## Product Change Notice (PCN)

## PCN Number: PCN-0450952R-01

Product(s) Affected: PJ-025

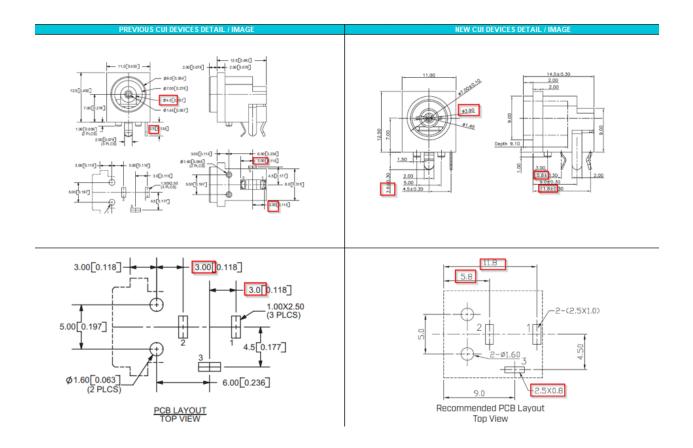
Description of Change: Minor Housing and footprint differences. Material Change on the housing and terminals. See image Below

PREVIOUS CUI DEVICES DETAIL / IMAGE				NEW CUI DEVICES DETAIL / IMAGE		
	MATERIAL	PLATING				
center pin	brass	tin	DESCRIPTION	MATERIAL	PLATING/COLOR	
terminal 1	brass	tin	terminal 1	bronze t=0.50	silver	
terminal 2	copper alloy	tin	terminal 2	bronze t=0.25	silver	
terminal 3	brass	tin	terminal 3	brass t=0.40	silver	
plastic	PBT		Insulator	PA66 (UL94V-0)	black	
MATING PLUG Jack Insertion Depth 9.0 mm			MATING PLUG Jack Insertion Depth: 9.1 mm			
		Ø1.4	········	MATING PLUG
